BZA N	umber:	155116
-------	--------	--------

SPECIAL PERMIT: 33, 35, 37 WEBSTER AVE.

**Subject:** Letter of appeal against the construction plan at 33-35 Webster Ave

My name is Zi Wang, owner of 6 Lilac Ct and an 8-year resident of Cambridge, together with my husband, Yuliang Leon Sun. We are writing to provide comments and raise concerns/objections to CASE NO. BZA-155116, the construction plan at 33 WEBSTER AVENUE by PARVIZ PARVIZI – C/O DANIEL ANDERSON, ARCHITECT (refer to as "the developer" henceforth).

Before and After view of impact of shade at one time point showing effect on sunlight into the gardens, to the tree and to the abutting properties

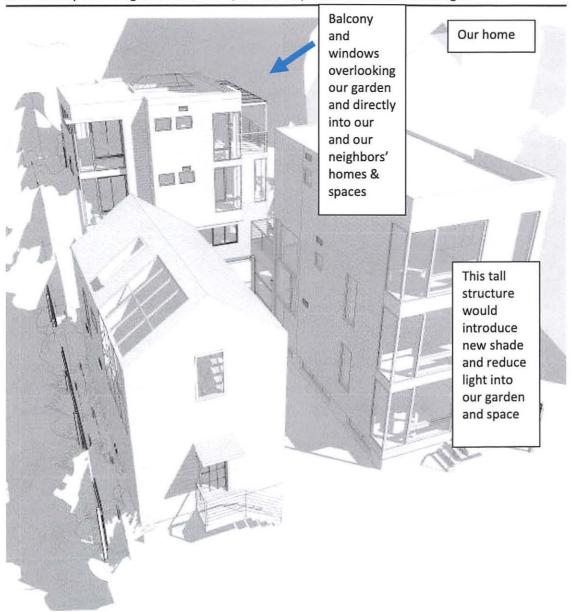
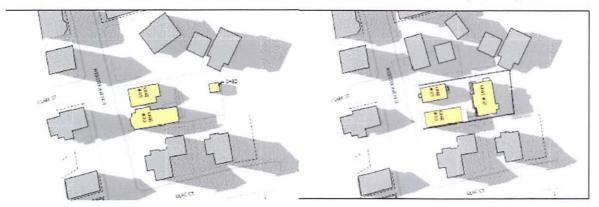
- The construction introduces meaningful risk to the large and rare American Elm tree that brings character to several of the abutting houses, including ours. If the tree and its roots are damaged by the construction and its survival is impeded by the necessary reduction in its root distribution, then the loss of the tree would be a preventable travesty to the community. There is reasonable justification for fear that the construction would have this predictable effect. The tree protection plan submitted by the applicant extends only one year, and the zoning board will have no capacity to hold the applicant accountable if he defaults on the submitted plan. A tree that does not survive this applicant's construction with its known and predictable risks to the roots and health of the tree could fall onto one of the local structures causing risk to persons and property if the application for an exception and variance is approved. What is more, any damage to the tree caused by the applicant's destruction might not be detectable for years.
